2131 Pittwater Road, Church Point

Geotechnical Comments for Section 4.55 Plans

We have reviewed the existing geotechnical report, the original plans, and the 15 amended plans by CHROFI, project 25002, drawings numbered DA501, revision 01. DA000 to 001, DA 100 to 103, DA200 to 201, DA300 to 301, DA400, DA500, and DA502 to 503, revision 03. All dated 24/06/2025.

GEOTECHNICAL INVESTIGATION:

SITE PLAN – showing test locations

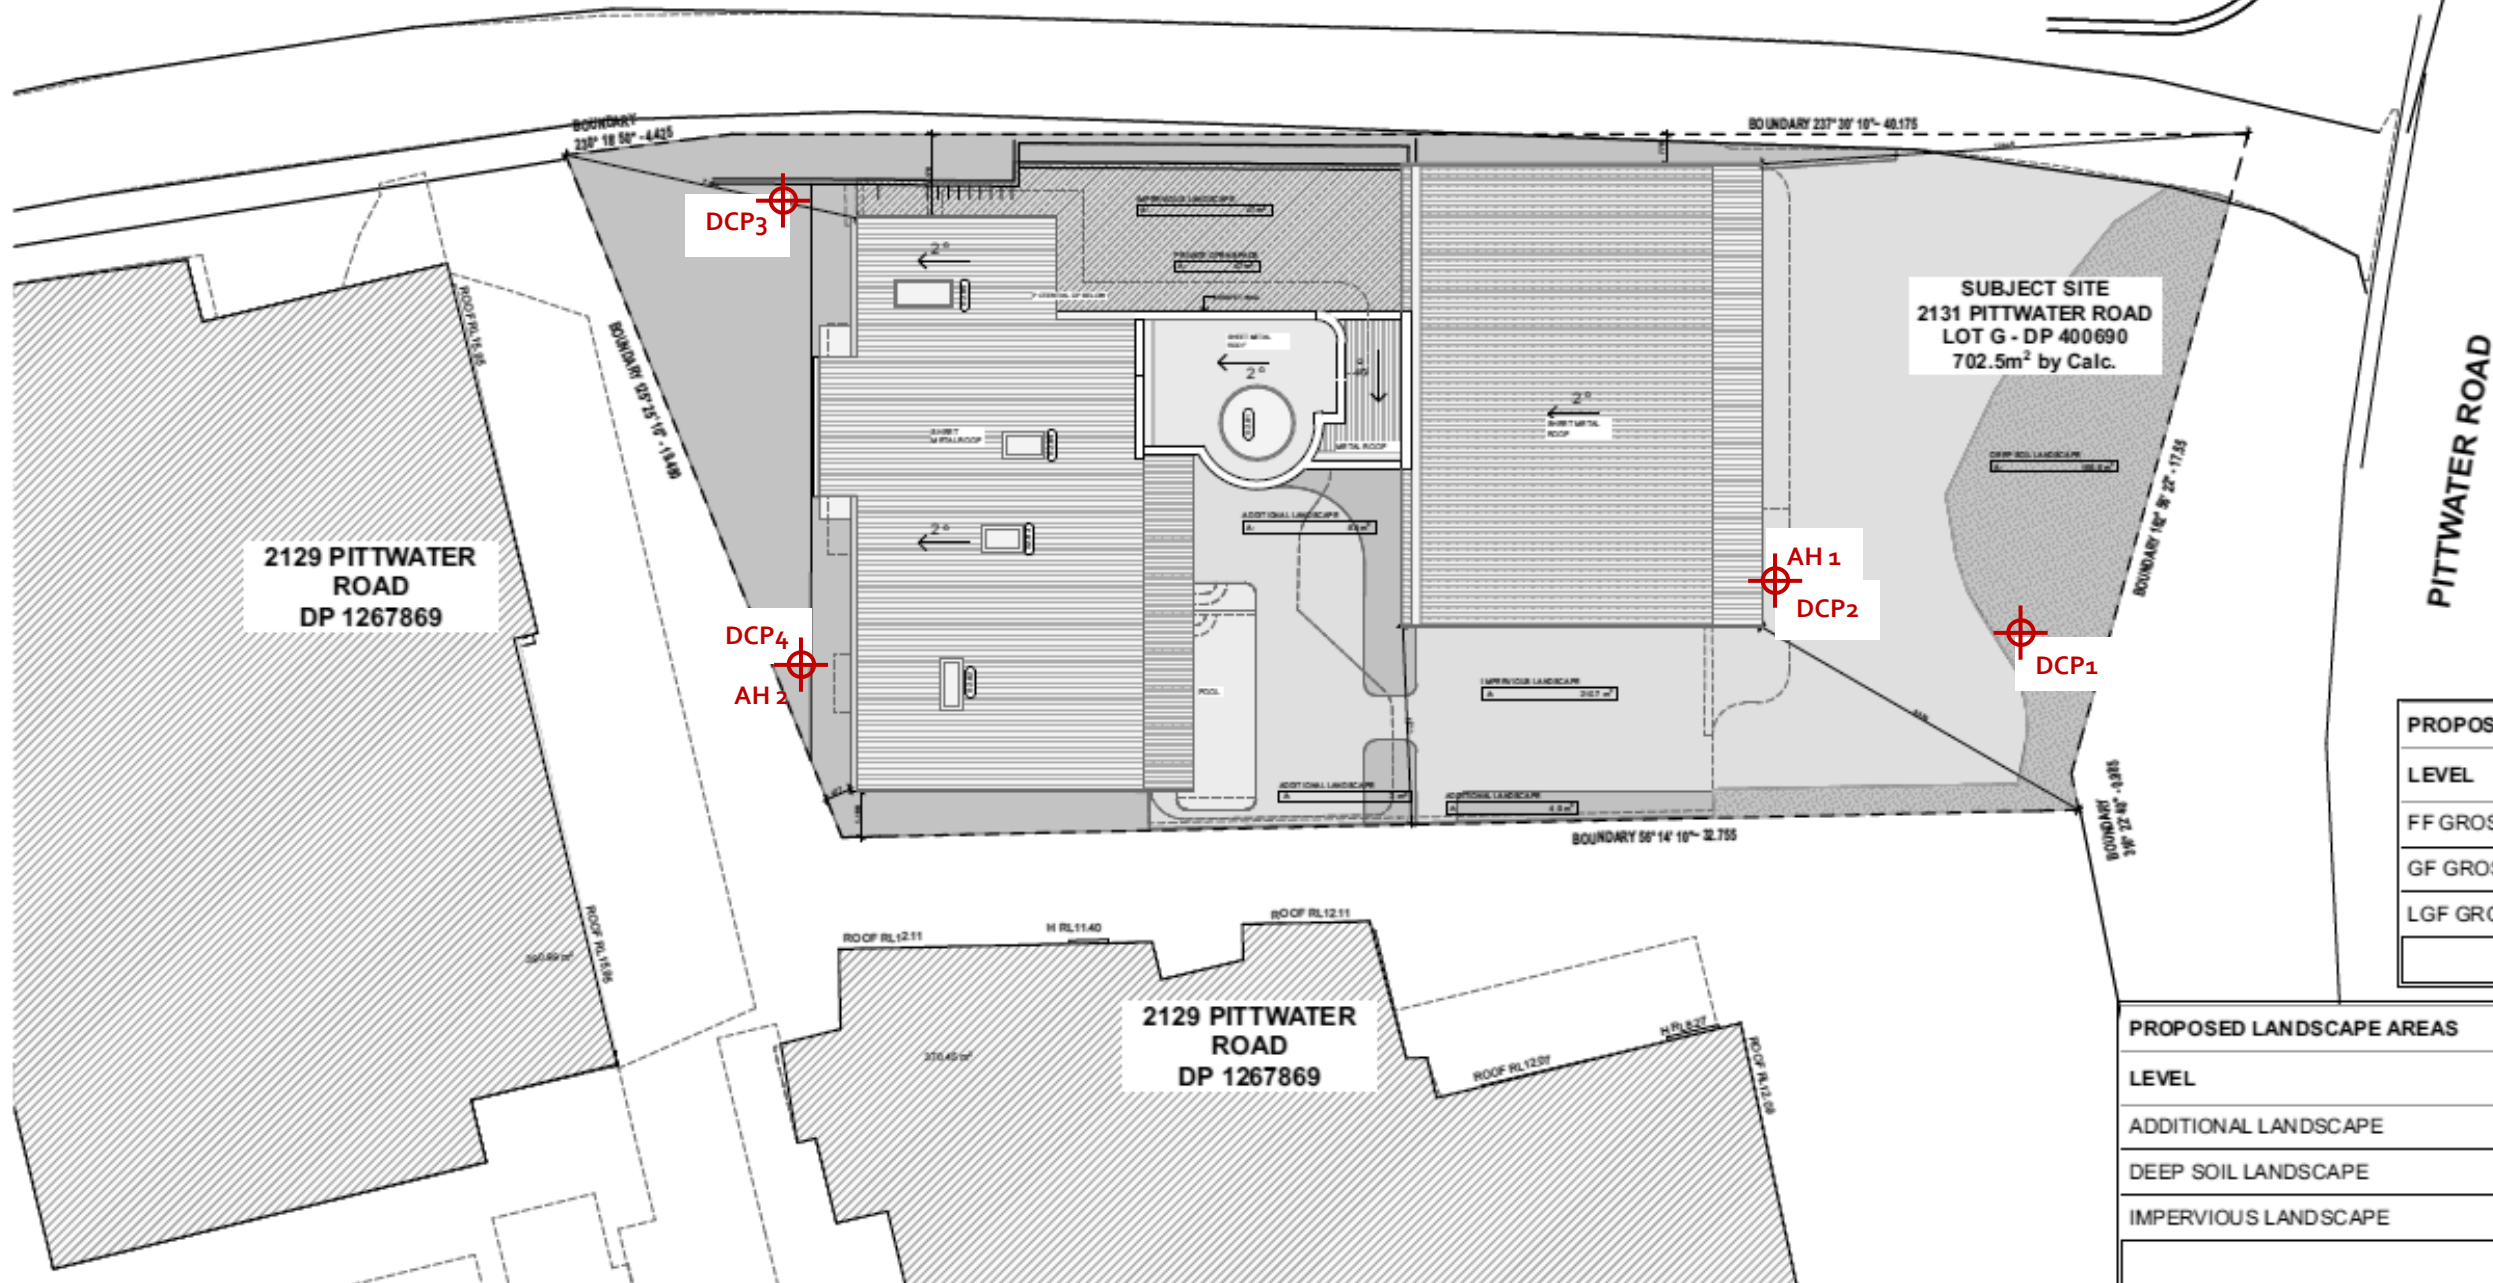
Two hand Auger Holes (AH) were put down to identify the soil materials. Four Dynamic Cone Penetrometer (DCP) tests were put down to determine the relative density of the overlying sand and the depth to weathered rock. The locations of the tests are shown on the site plan attached. It should be noted that a level of caution should be applied when interpreting DCP test results. The test will not pass through hard buried objects so in some instances it can be difficult to determine whether refusal has occurred on an obstruction in the profile or on the natural rock surface. This is not expected to have been an issue for this site. But due to the possibility that the actual ground conditions vary from our interpretation there should be

LOWER GROUND FLOOR PLAN – showing minimum extent of required shoring / potential underpinning

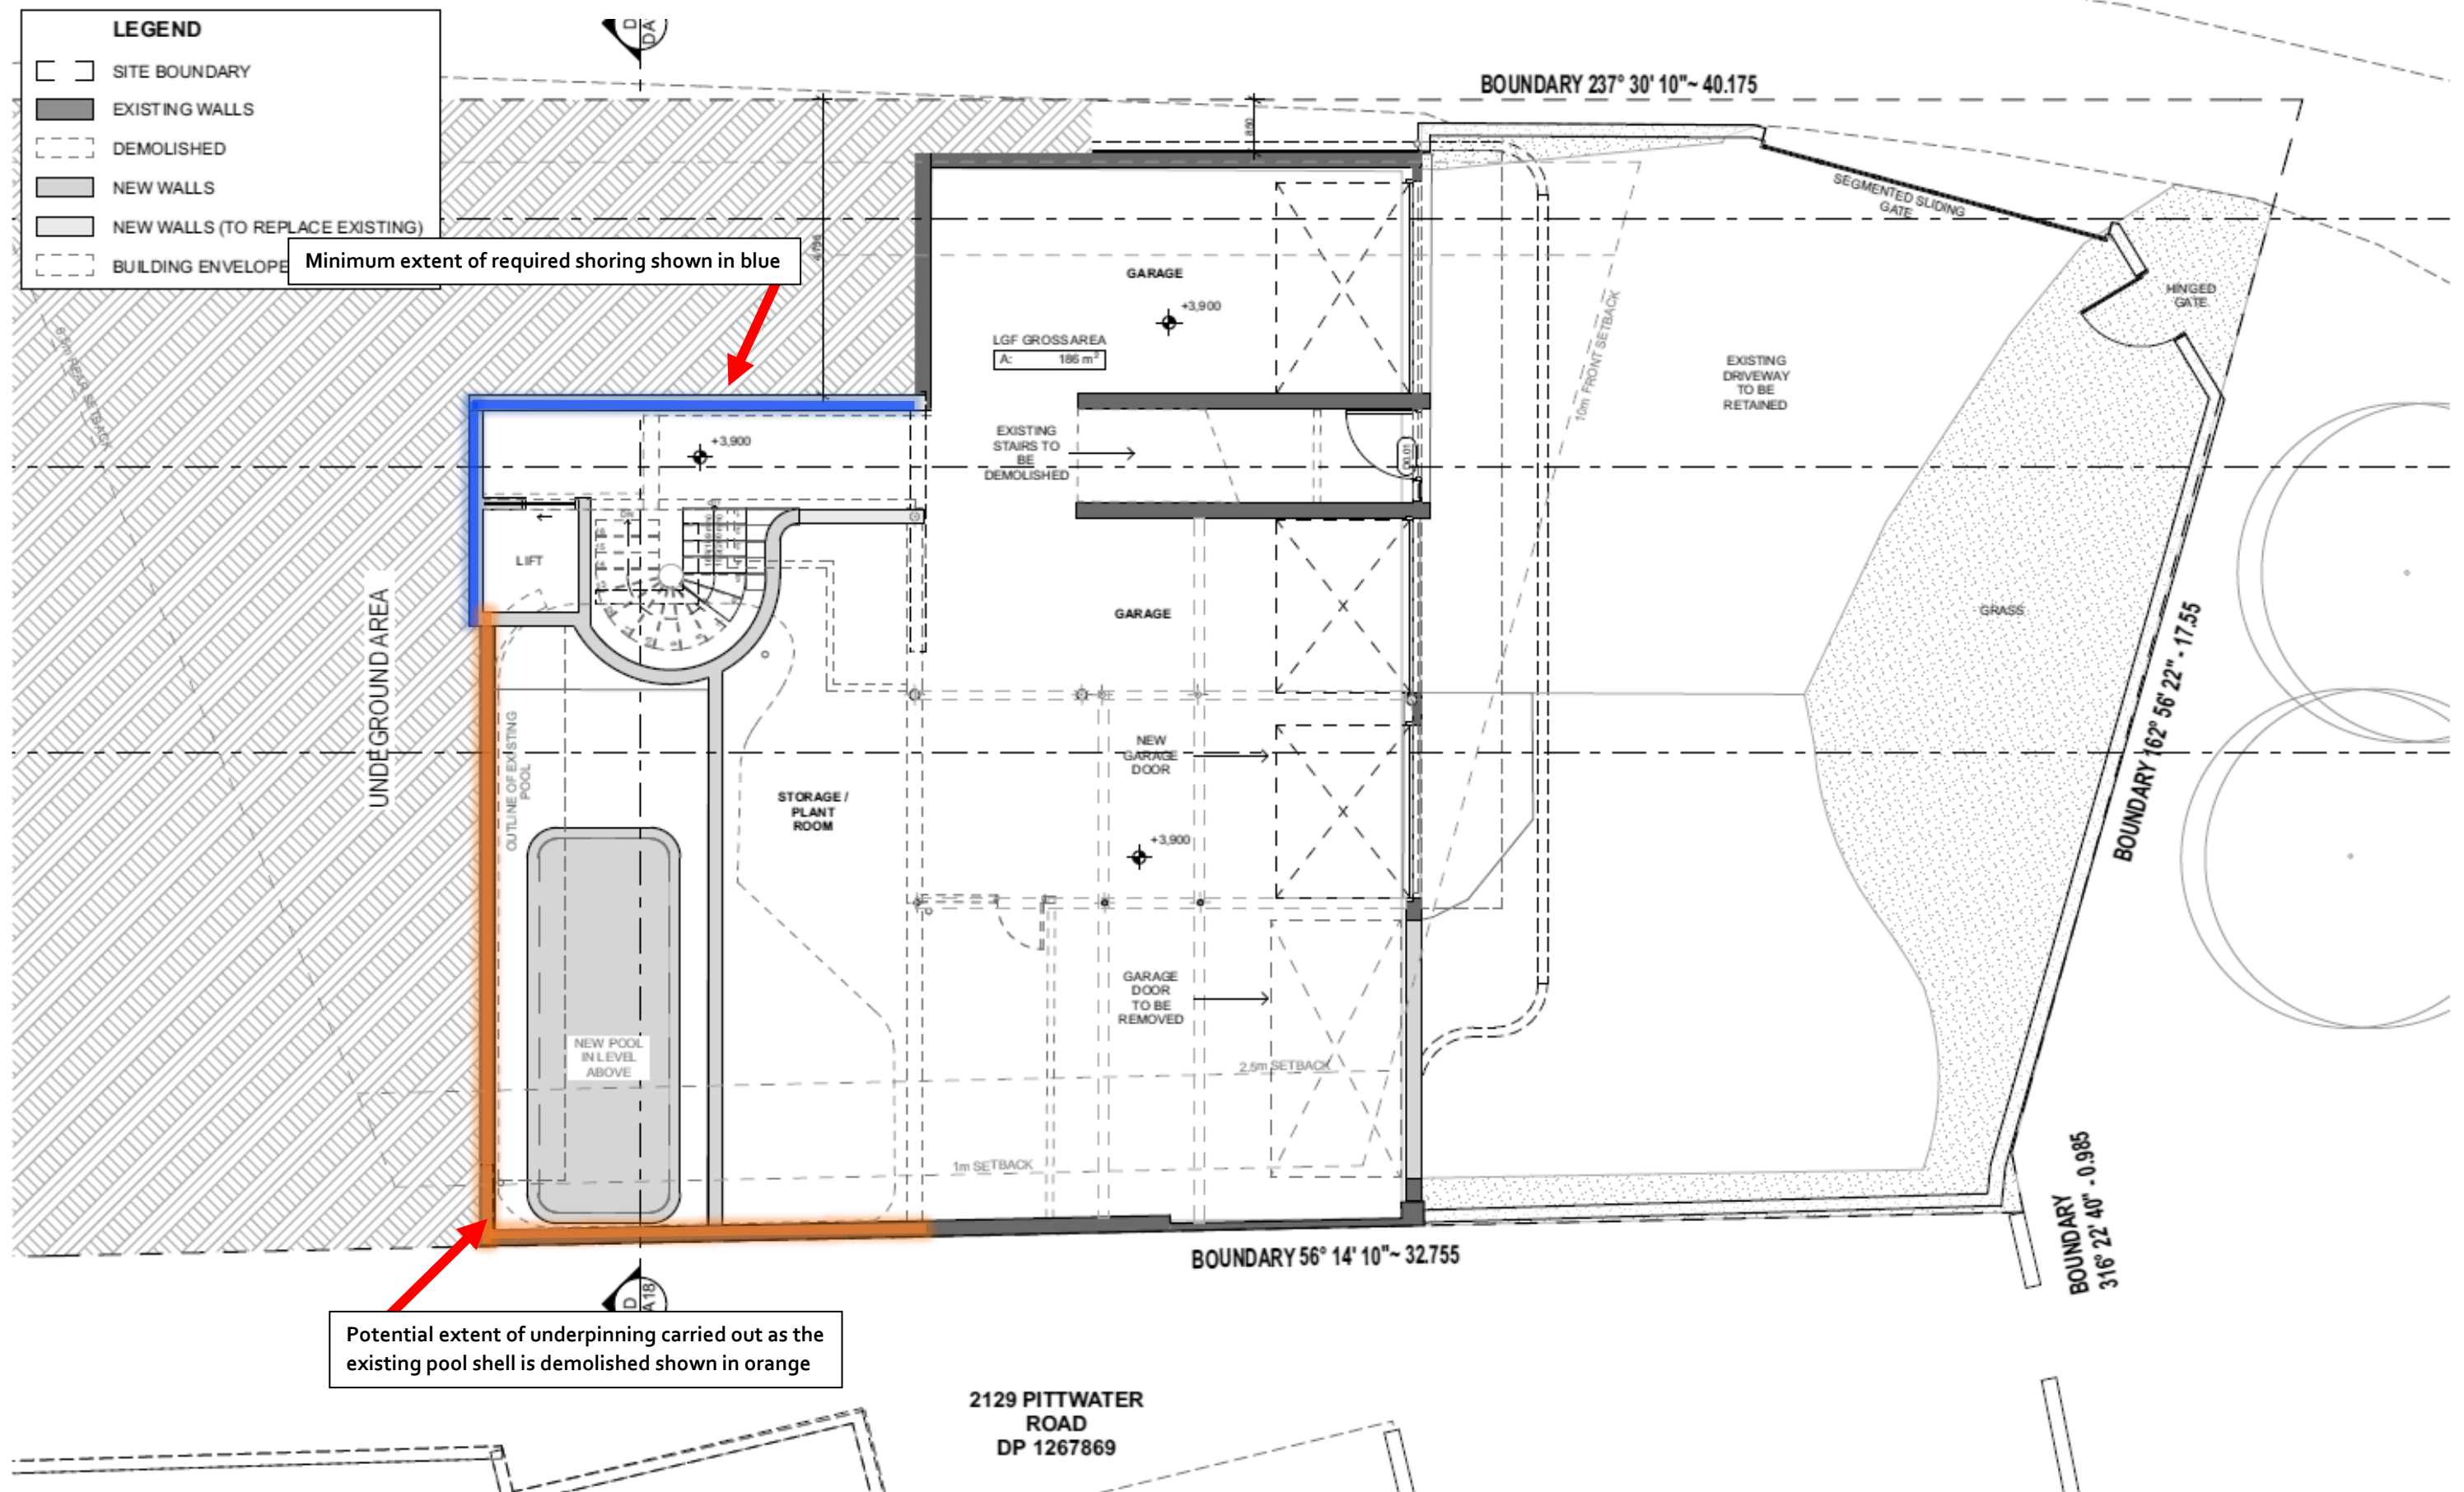
If the foundations are confirmed to extend below the zone of influence of the proposed excavation, the excavation may commence. If they are not, the walls will need to be underpinned to below the zone of influence of the cut prior to the excavation commencing. See the site plan attached for the minimum extent of the required exploration pits/underpinning.

unsupported. The support will need to be designed / approved by the structural engineer. See the site plan attached for the minimum extent of the required shoring shown in blue.

GROUND FLOOR PLAN – showing minimum extent of required shoring / exploration pits / underpinning

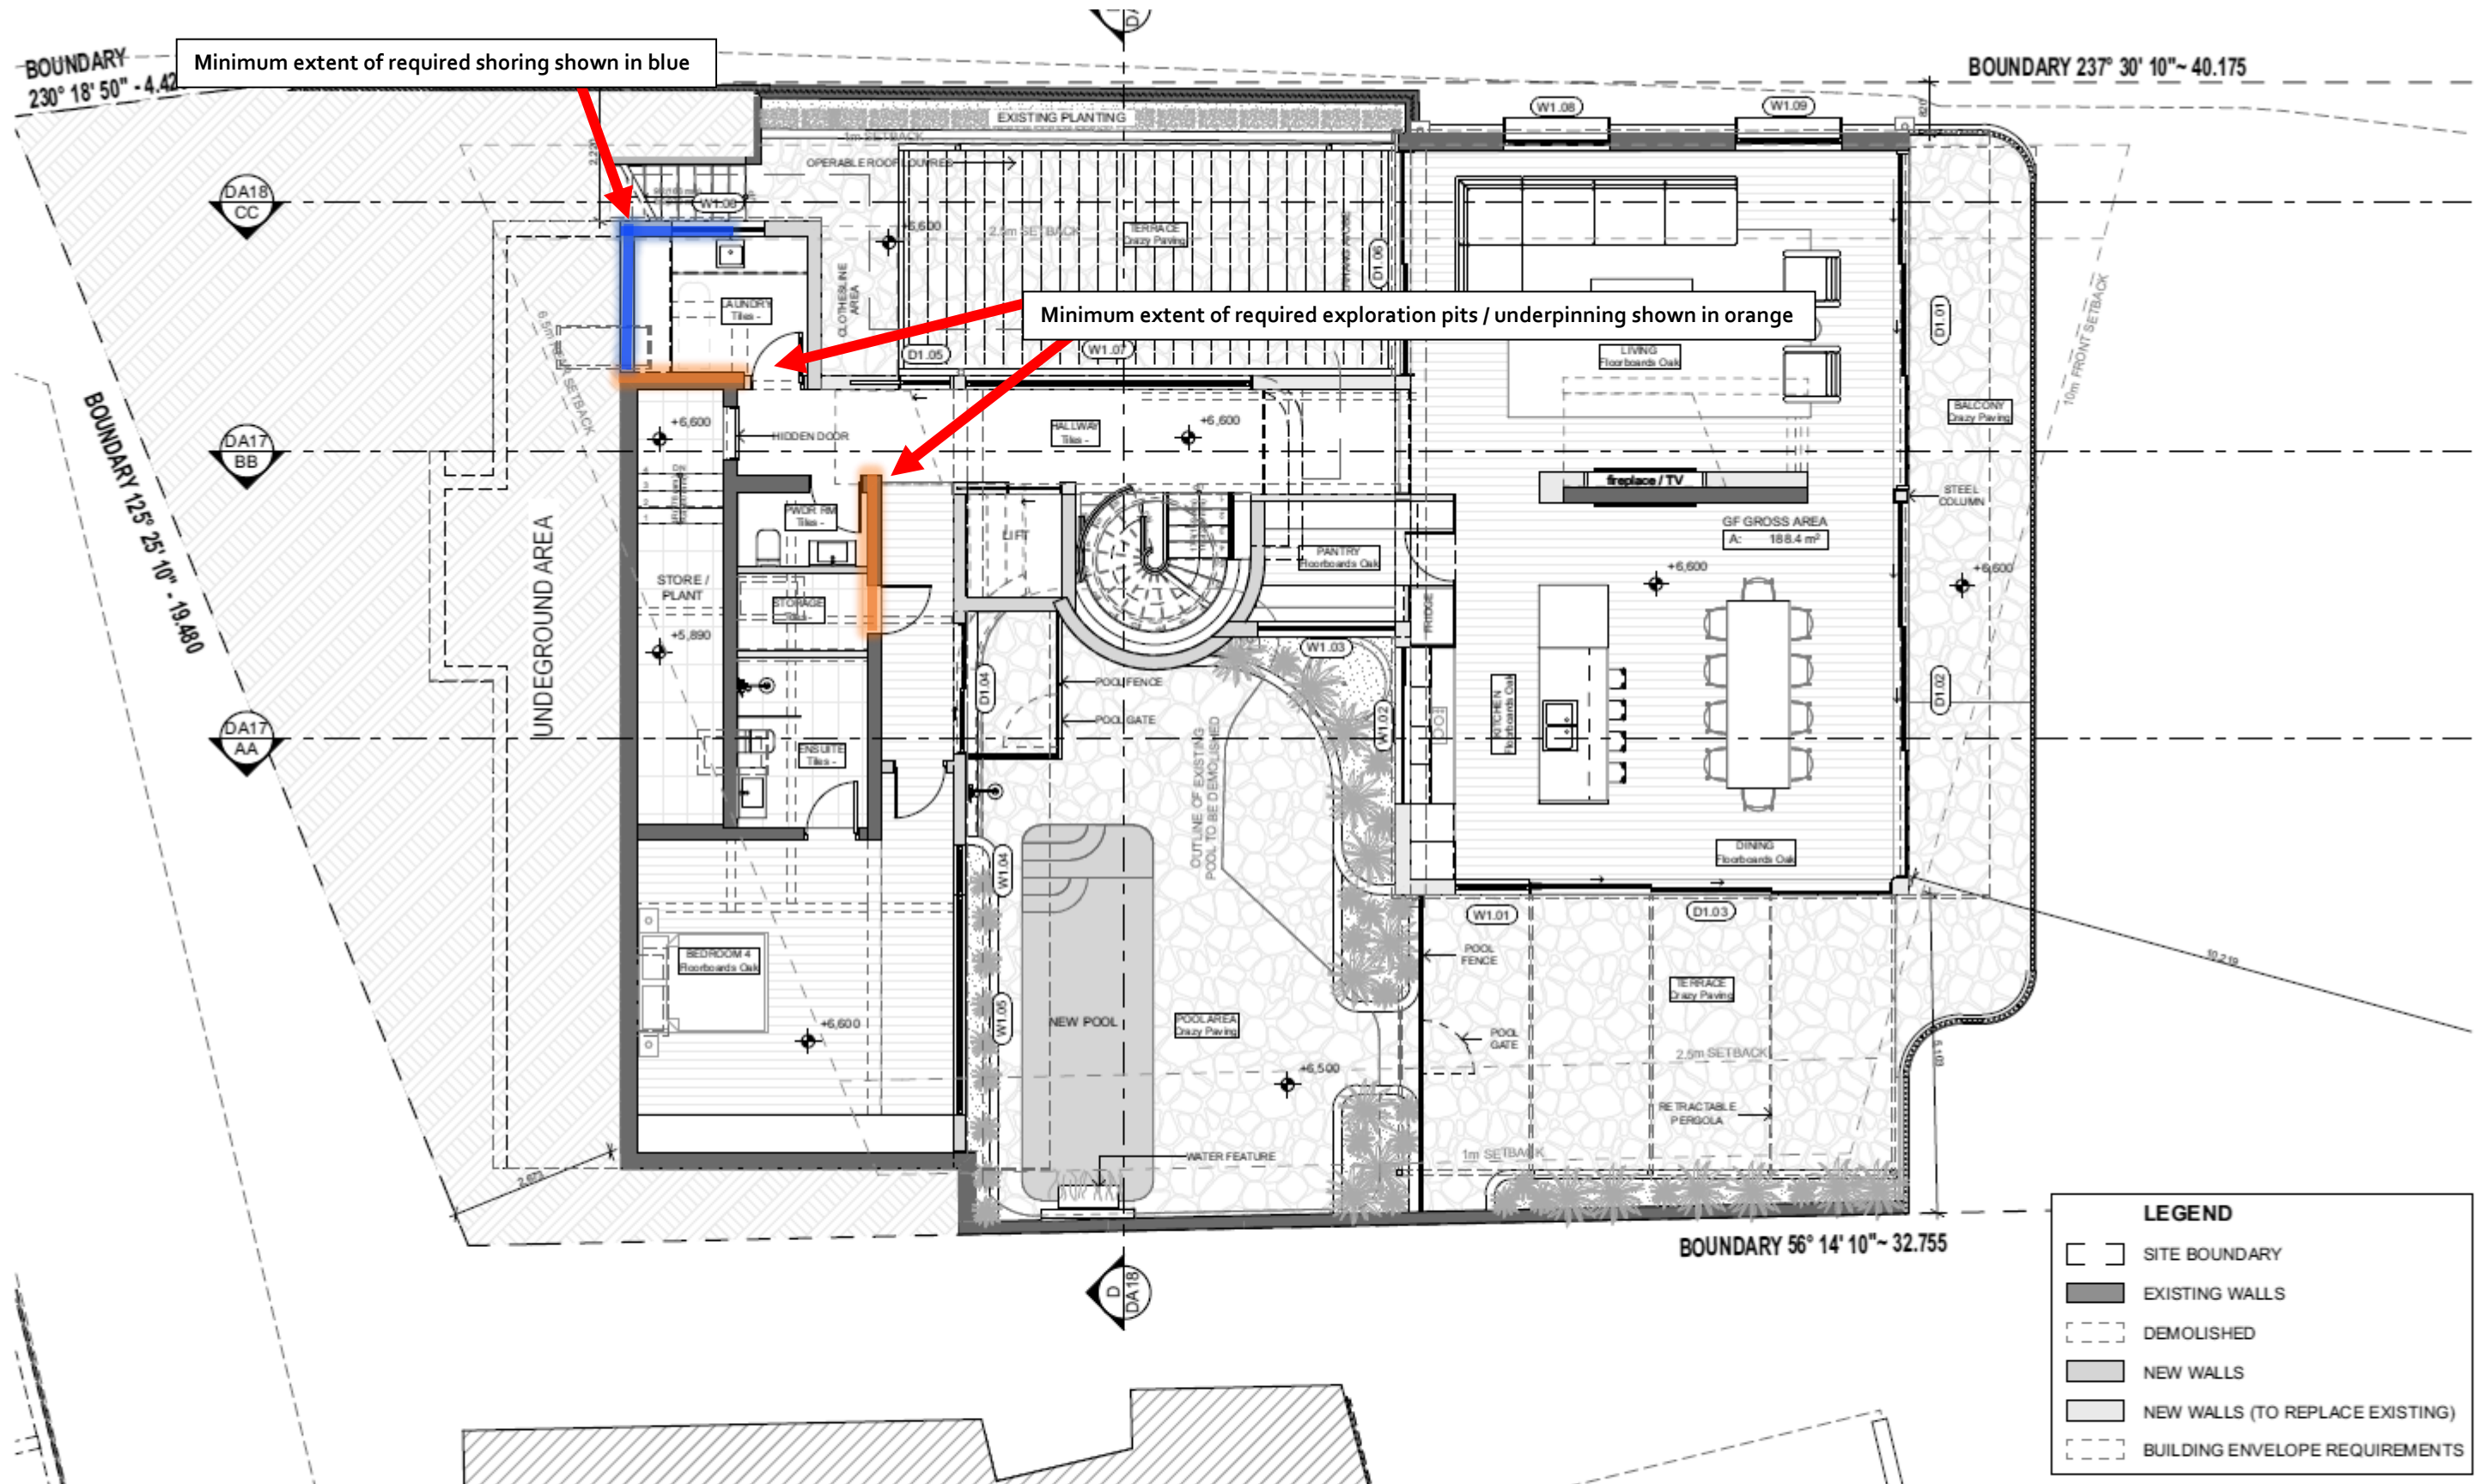
Following the demolition of any non-retaining structures, where any walls that are to remain fall within the zone of influence of any excavations, exploration pits along the walls will need to be put down by the builder to determine the foundation depth and material. These are to be inspected by the geotechnical consultant.
